**FILE** BRST-189-1(30) Gwinnett County  
P. I. No. 132986

**SUBJECT** PROJECT CONCEPT REPORT APPROVAL

### SUBJECT PROJECT CONCEPT REPORT

PROJECT CONCEPT REPORT

GEORGIA  
DEPARTMENT OF TRANSPORTATION  
CONCEPT TYPICAL SECTIONS  
PROJECT BRST-189-11301  
COUNTY: GWINNETT  
DATE: SH

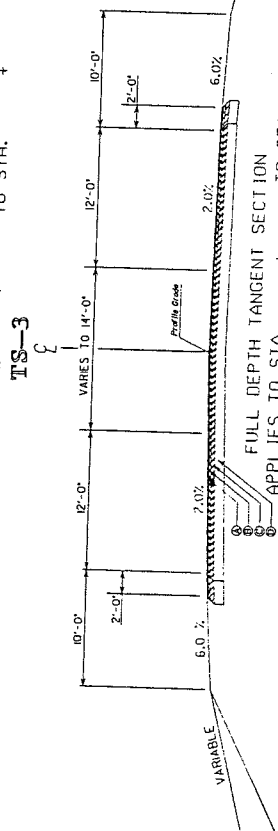
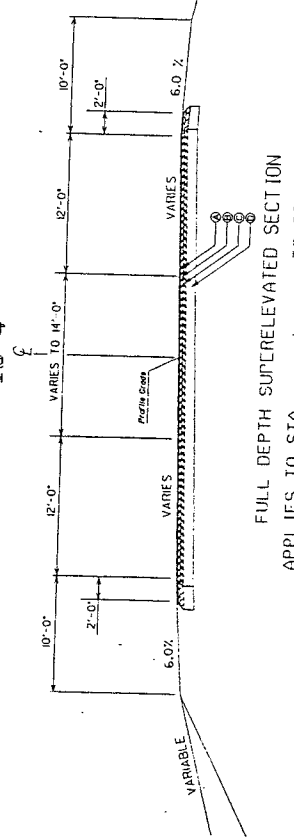
Johnny also asked that we revise our typical section pavement design. (This may slightly alter our cost estimate.) He recommended we revise pavement course A to be 12.5 mm superpave at 165 psy rather than 9.5mm at 135 psy, pavement course C to be 12" GAB rather than 6", and pavement course D to be 550 psy rather than 660psy.

- ① 12.5 mm ASPHALTIC CONCRETE SUPERPAVE - 135 LB/SY
- ② 19 mm RECYCLED ASPHALTIC CONCRETE SUPERPAVE - 220 LB/SY
- ③ GRADED AGGREGATE BASE, 12" ALTERNATE 1)
- ④ 25 mm RECYCLED ASPHALTIC CONCRETE SUPERPAVE - 550 LB/SY (ALTERNATE 2)
- ⑤ ASPHALTIC CONCRETE LEVELING, AS REQUIRED
